Addendum #02

Fox Pointe Townhomes
800-927 23rd Ave NW
Austin, MN 55912

8/31/17

615-19

A212

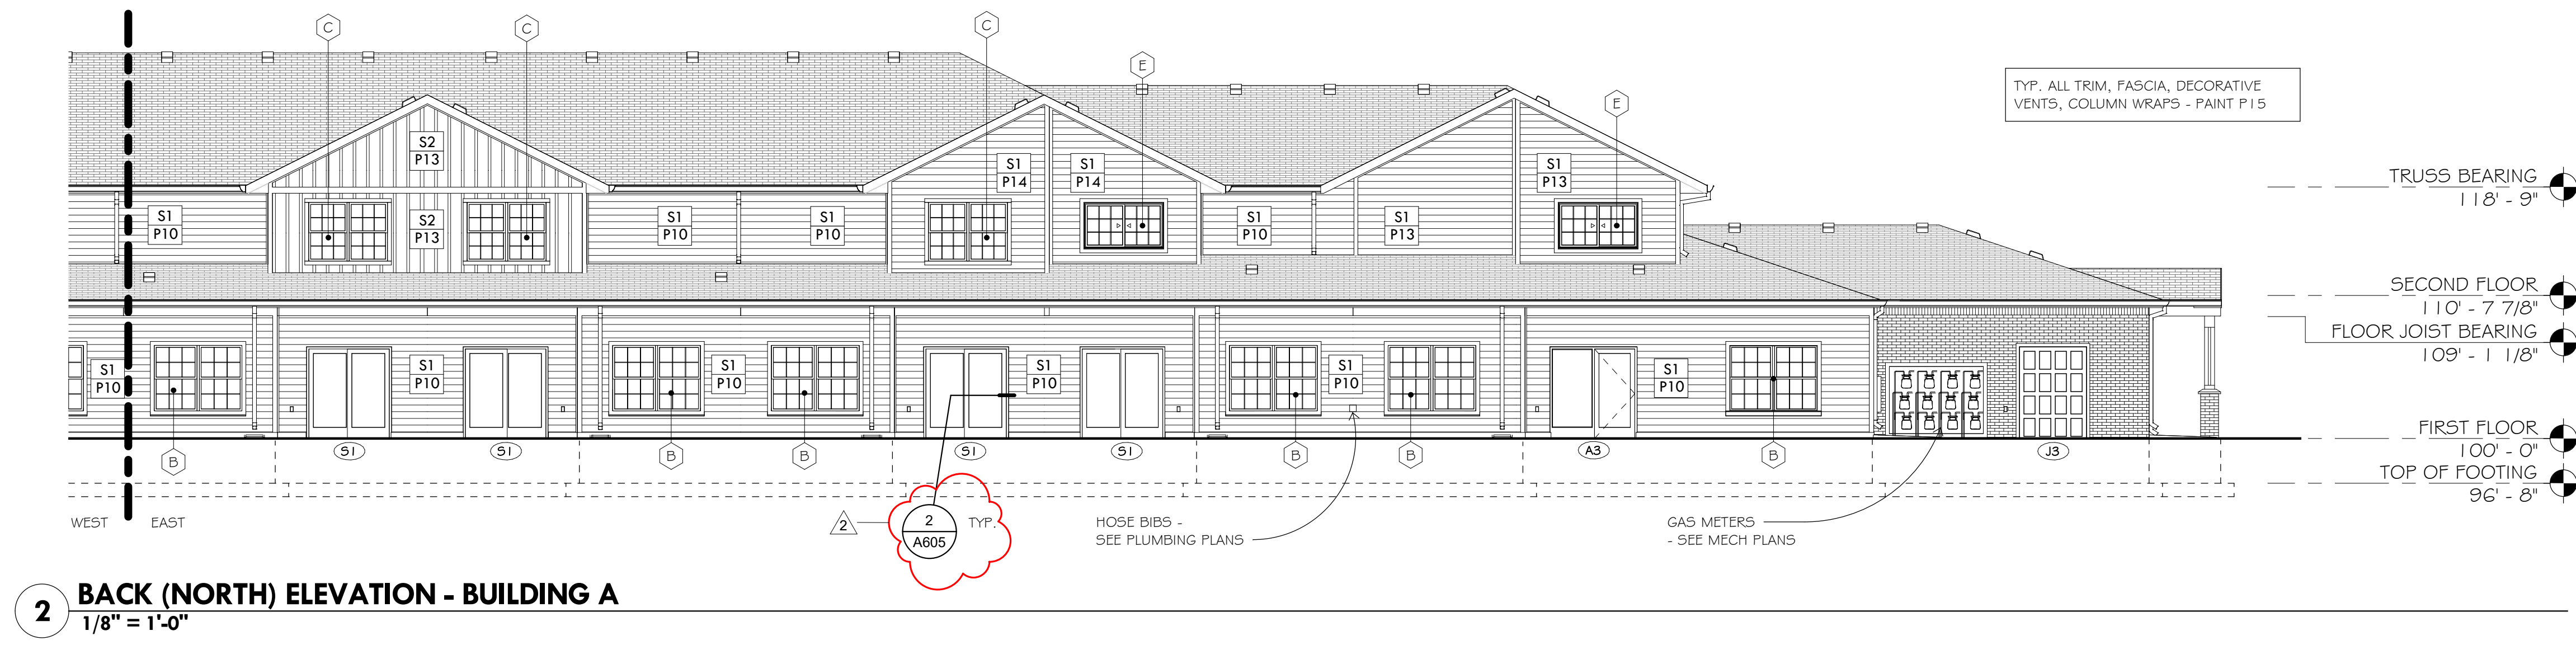
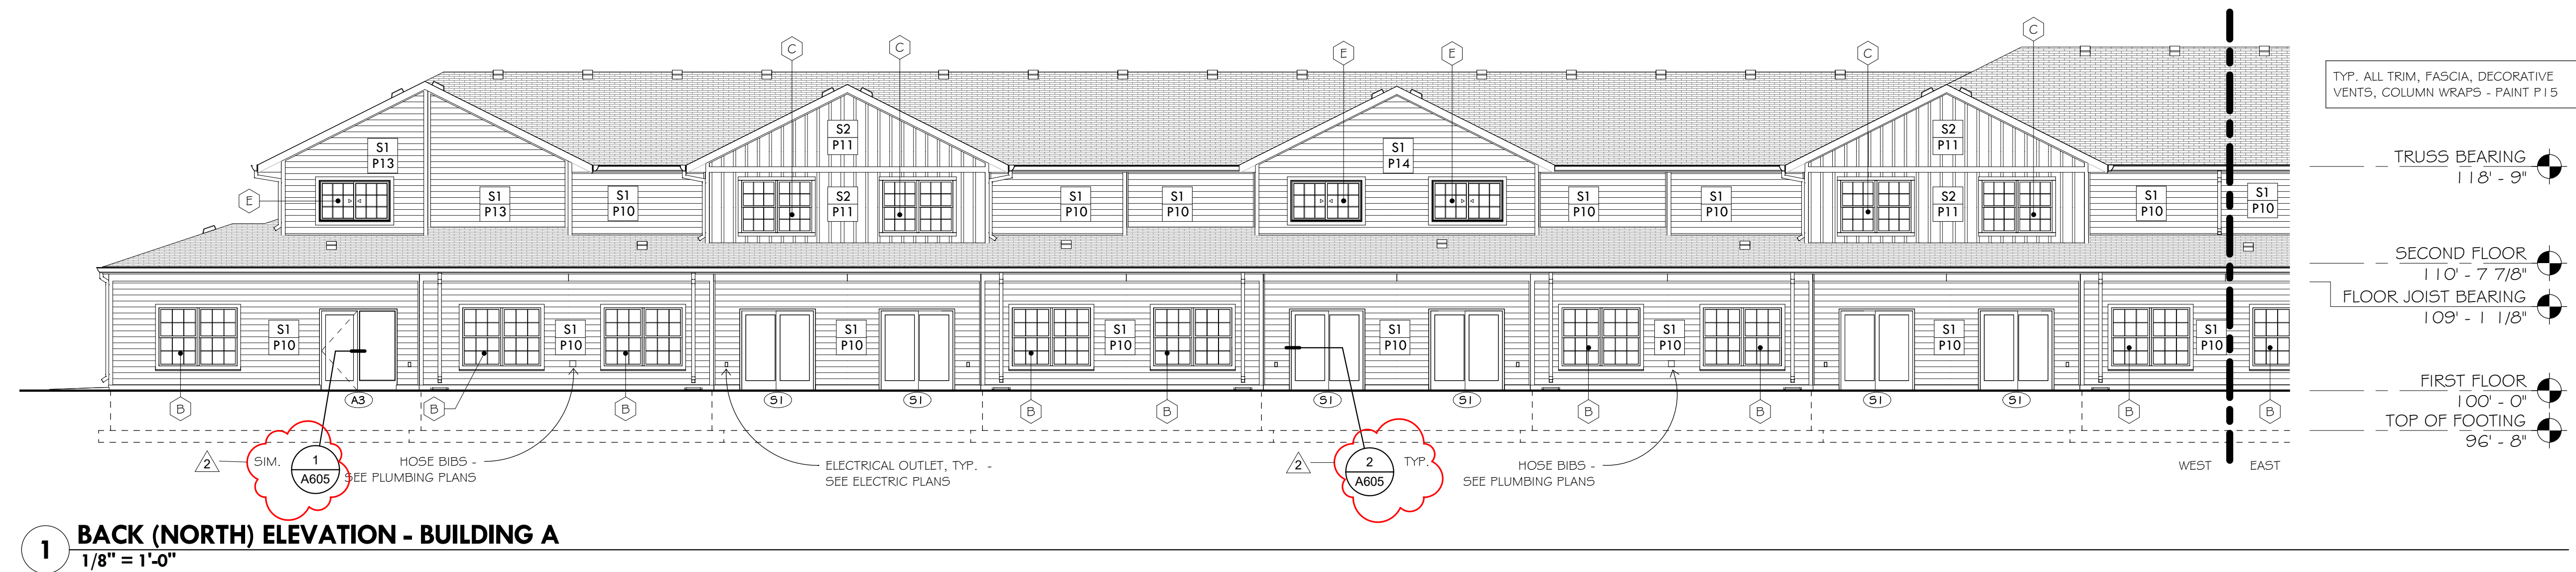
- 1. Refer to A212 – EXTERIOR ELEVATIONS – BUILDING A
 - a. Elevations modified this addendum to clarify details.
- 2. Refer to A222 – EXTERIOR ELEVATIONS – BUILDING B

A222

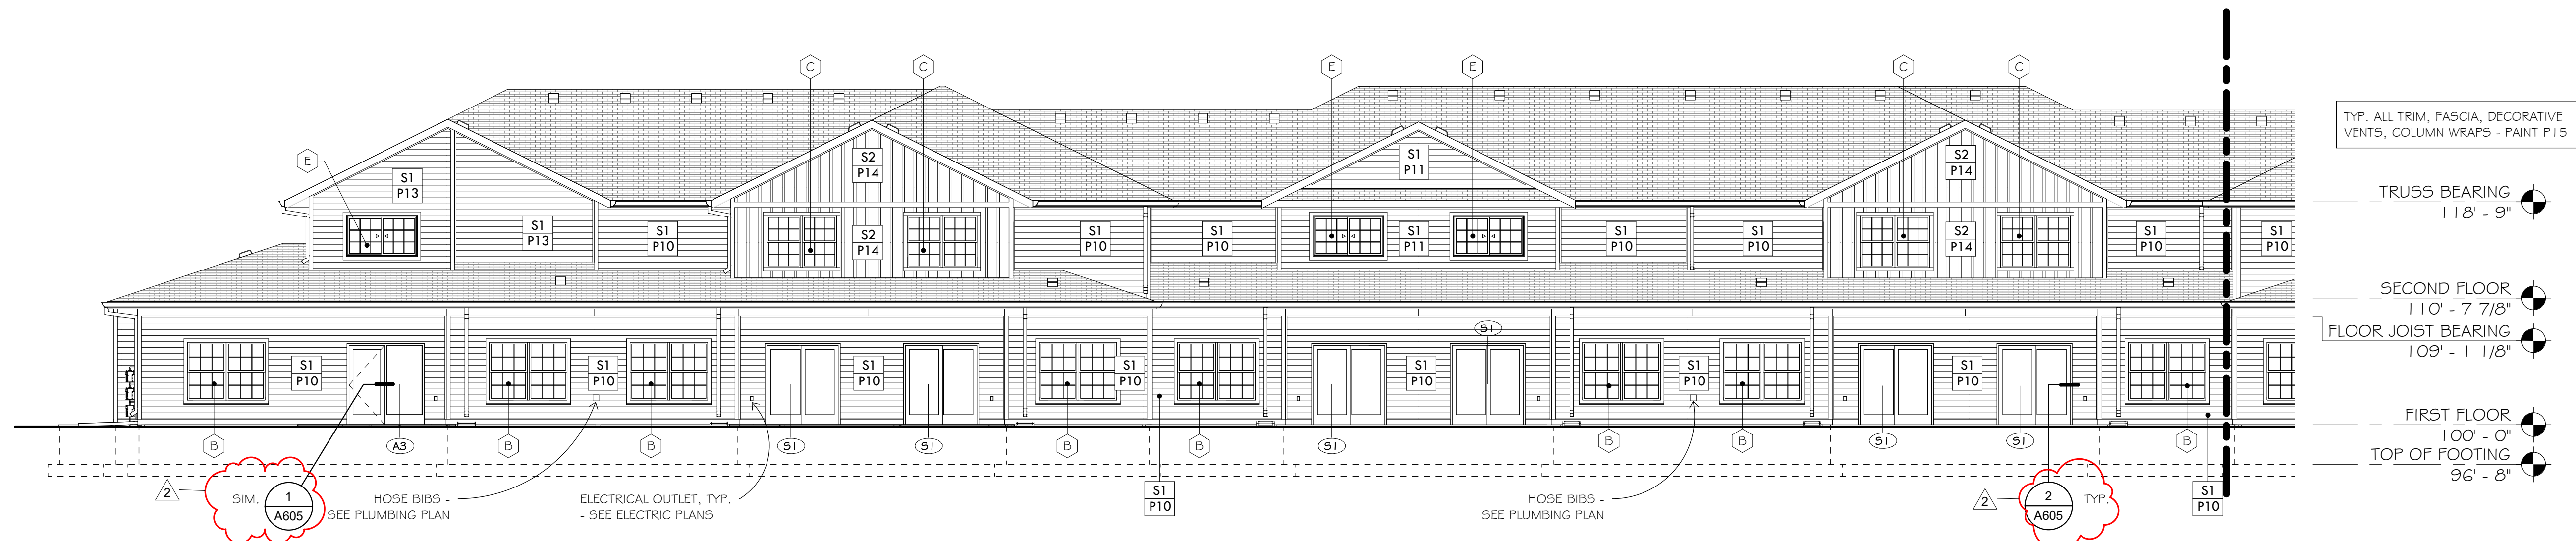
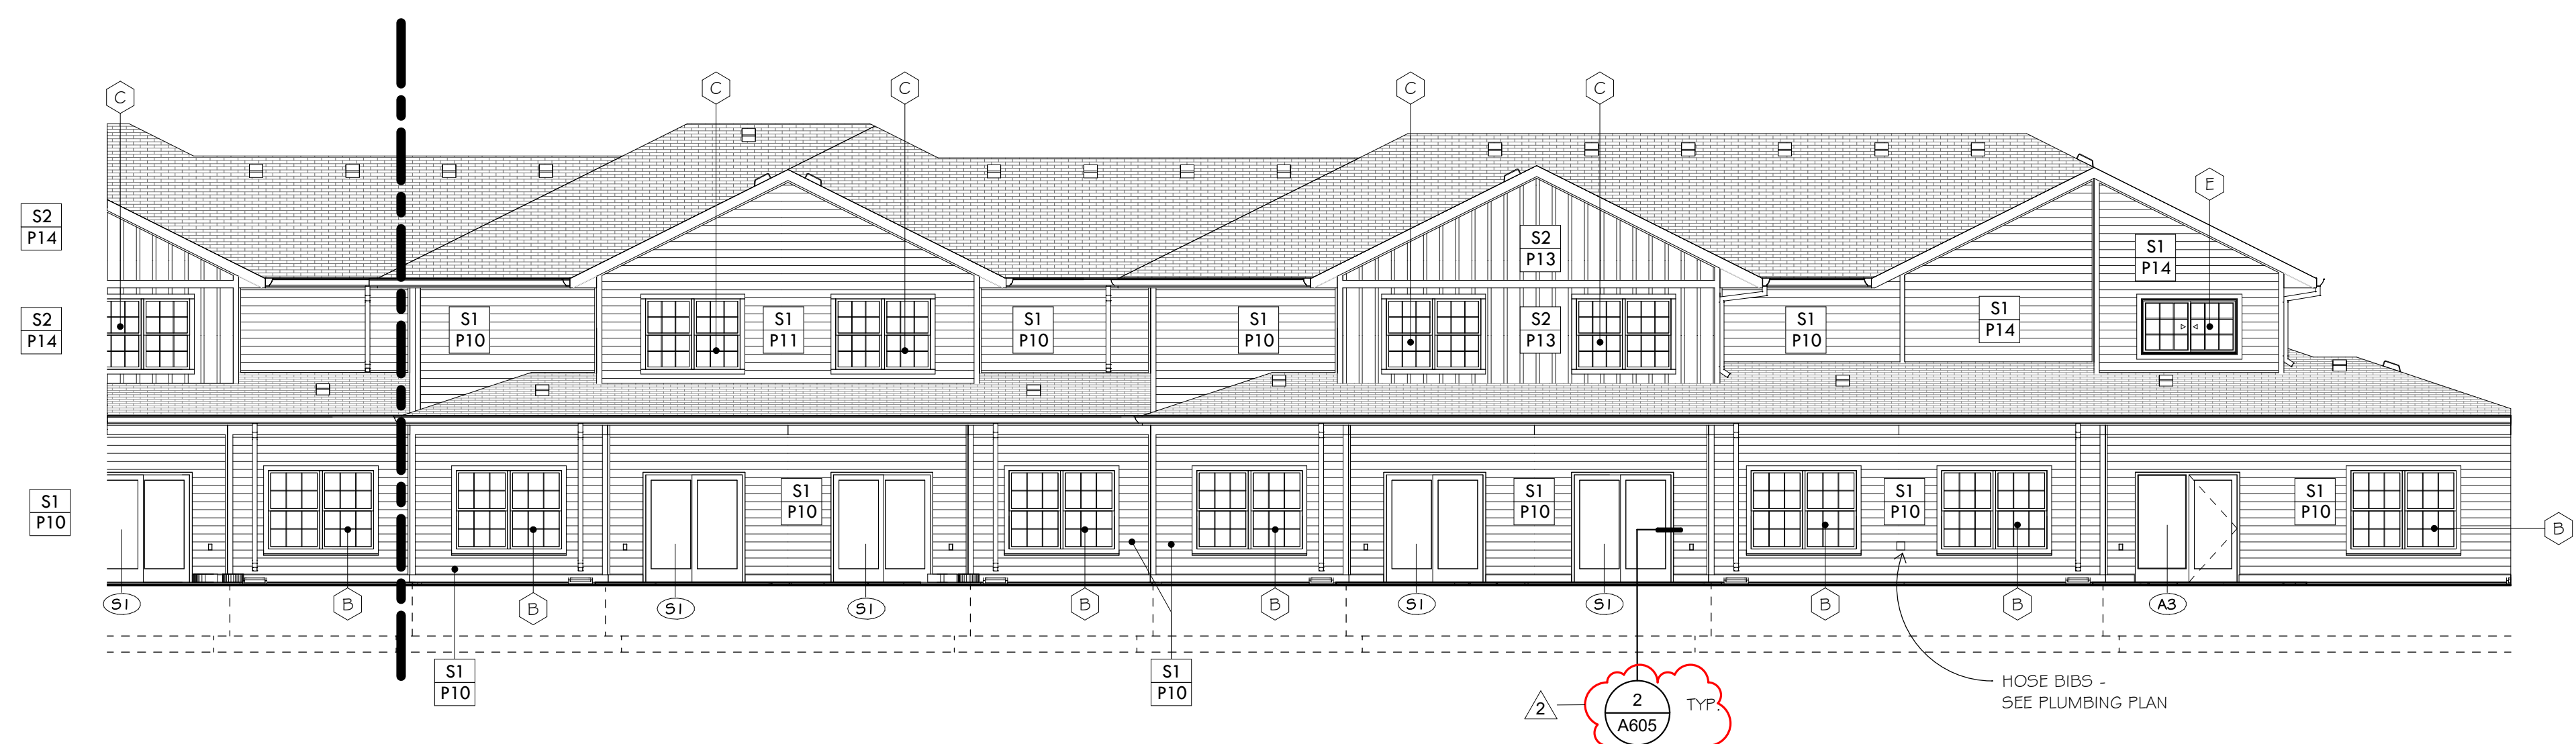
- a. Elevations modified this addendum to clarify details.
- 3. Refer to A232 – EXTERIOR ELEVATIONS – BUILDING C
 - a. Elevations modified this addendum to clarify details.

8 GARAGE DOOR HEAD AT BRICK
3" = 1'-0"

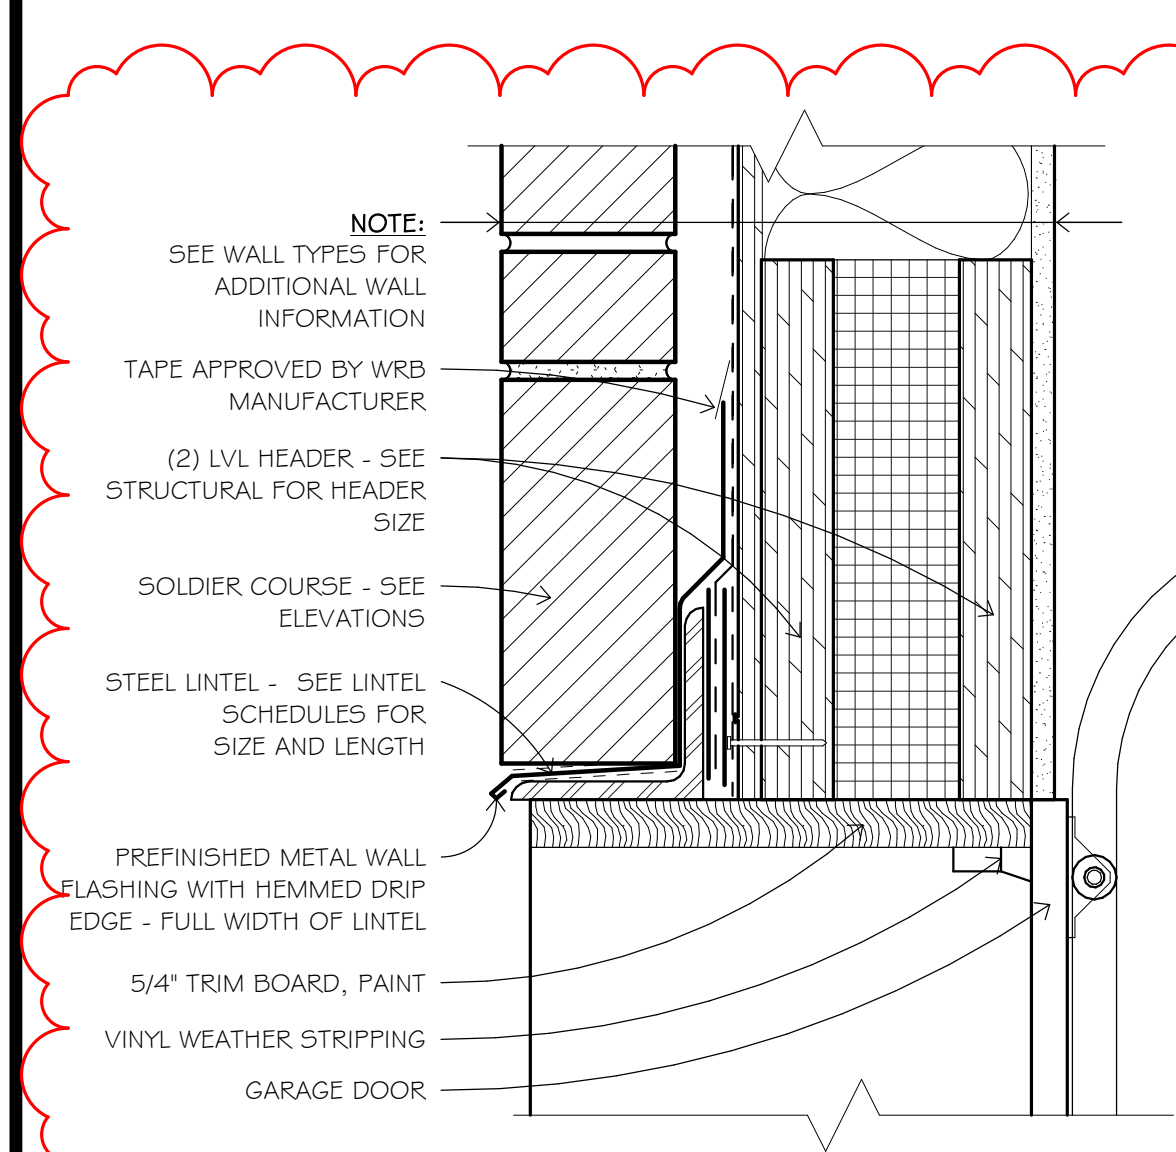
- 4. Refer to A603 – EXTERIOR DETAILS - OPENINGS
 - a. Detail 8/A603- GARAGE DOOR HEAD AT BRICK – modified this addendum
- 5. Refer to A604 – EXTERIOR DETAILS - OPENINGS

2 DOOR JAMB DETAIL @ SIDING
6" = 1'-0"

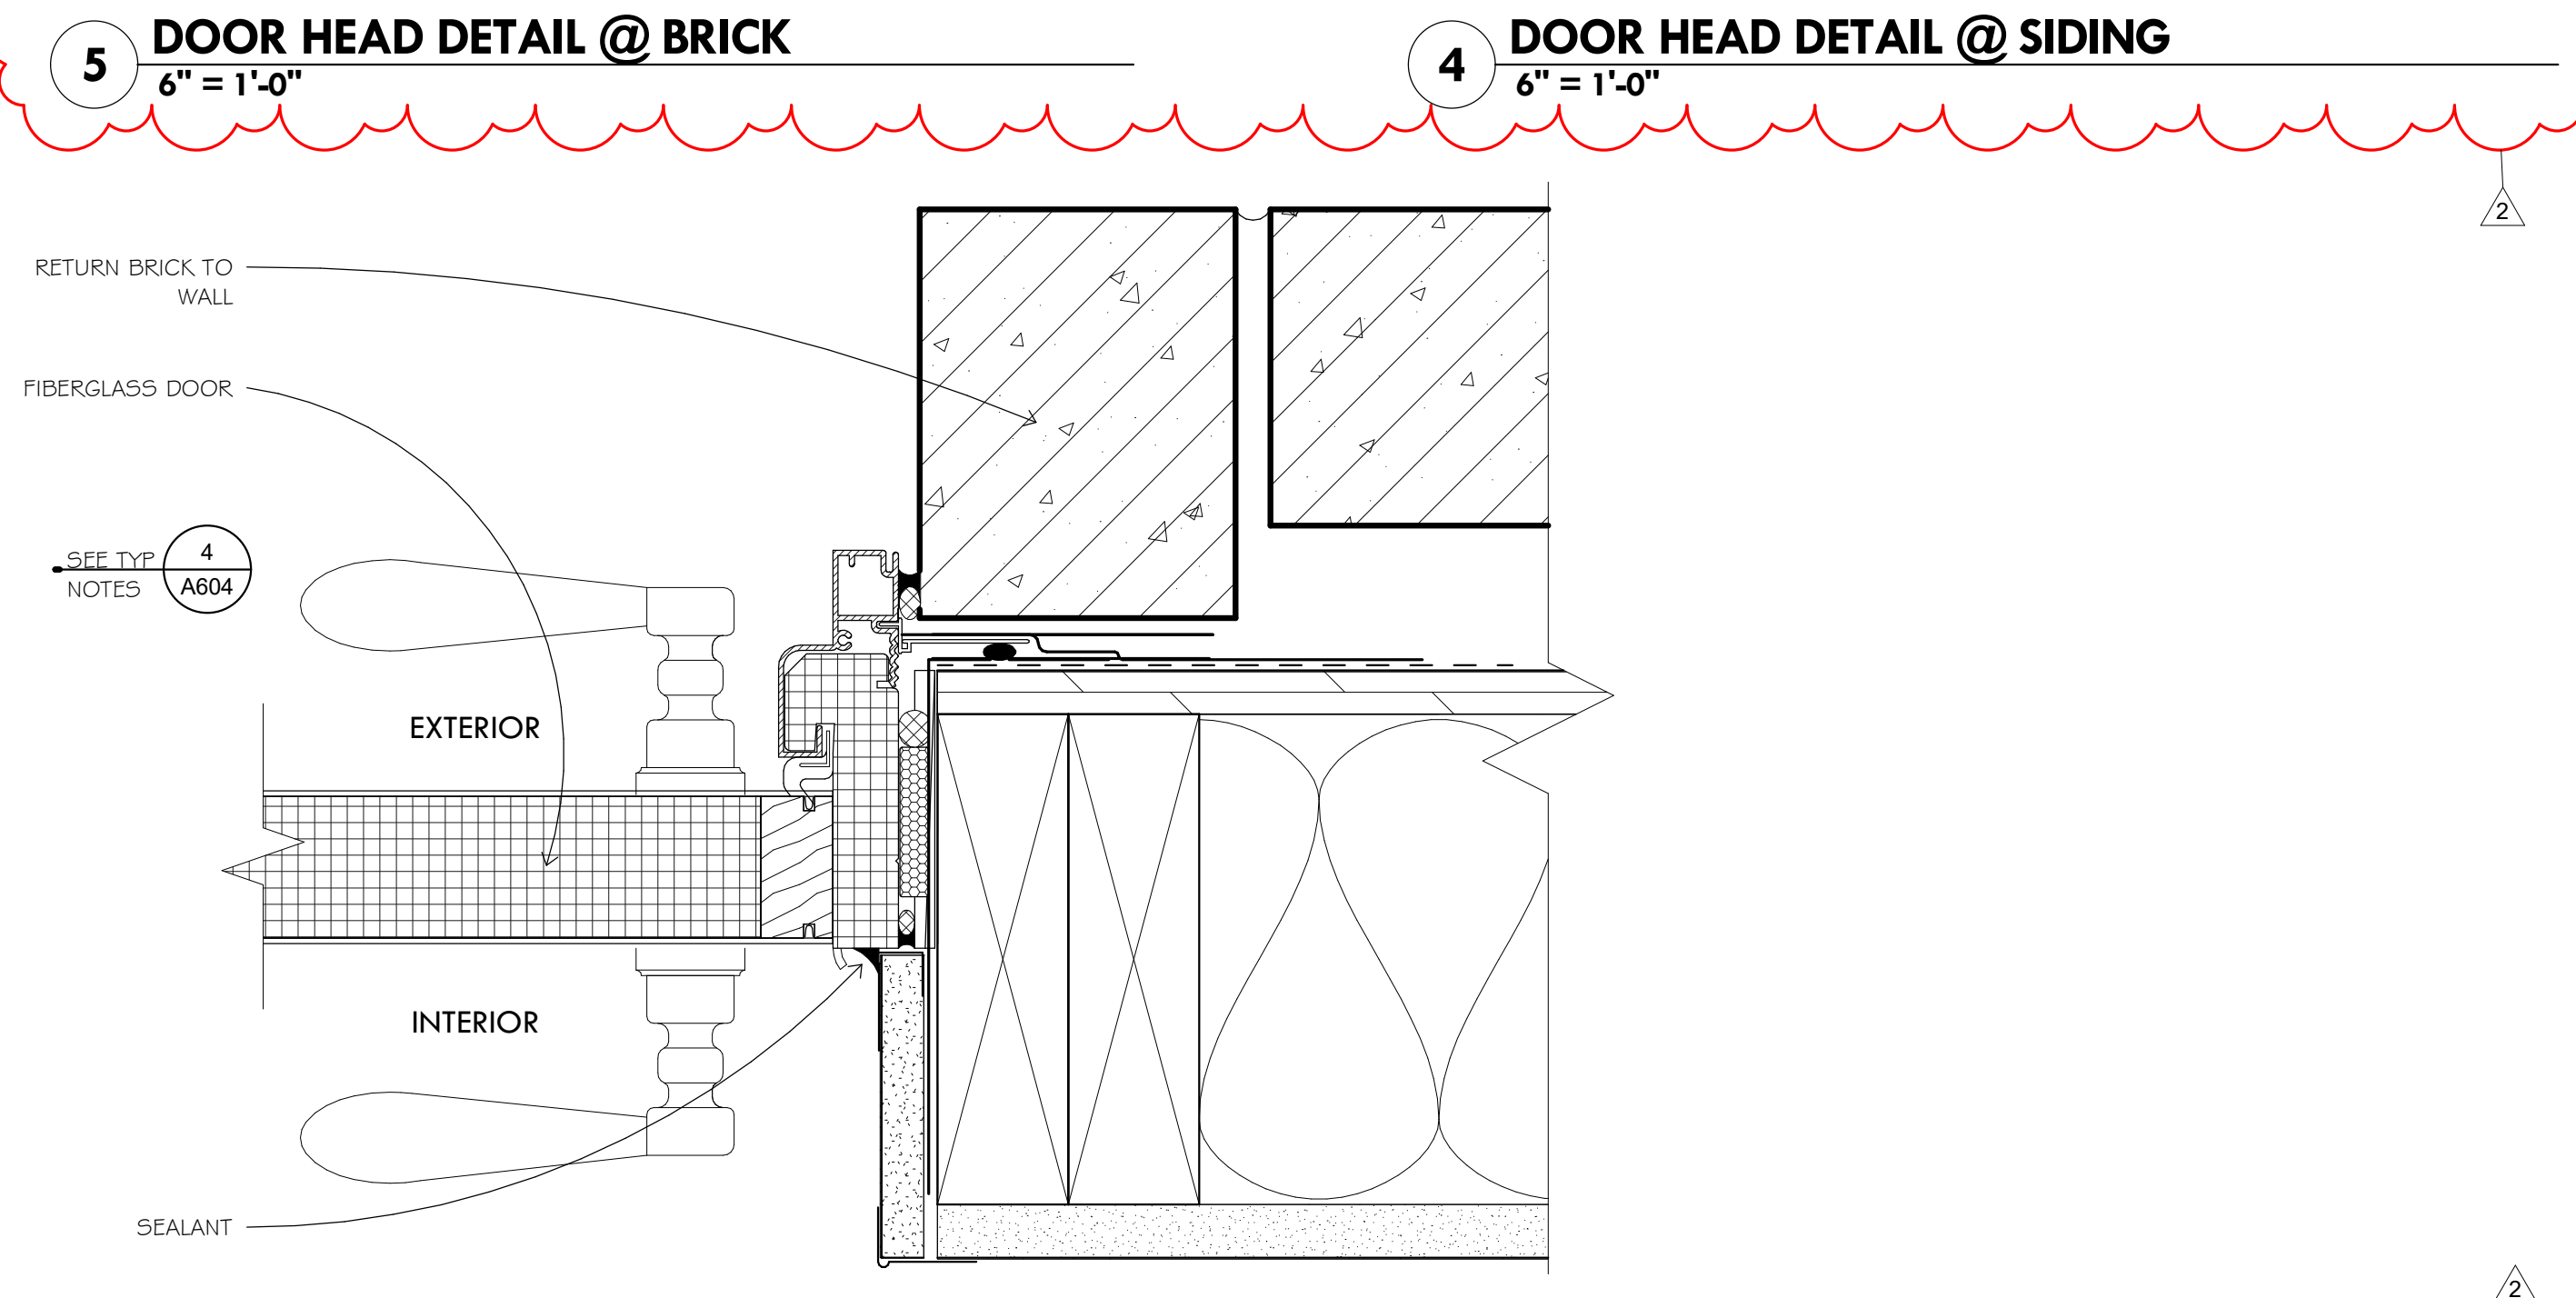
- a. Detail 1/A604- SILL DETAIL @ ENTRY DOOR – modified this addendum
 - b. Detail 2/A604- DOOR JAMB DETAIL @ SIDING – modified this addendum
 - c. Detail 4/A604 – DOOR HEAD DETAIL @ SIDING – modified this addendum
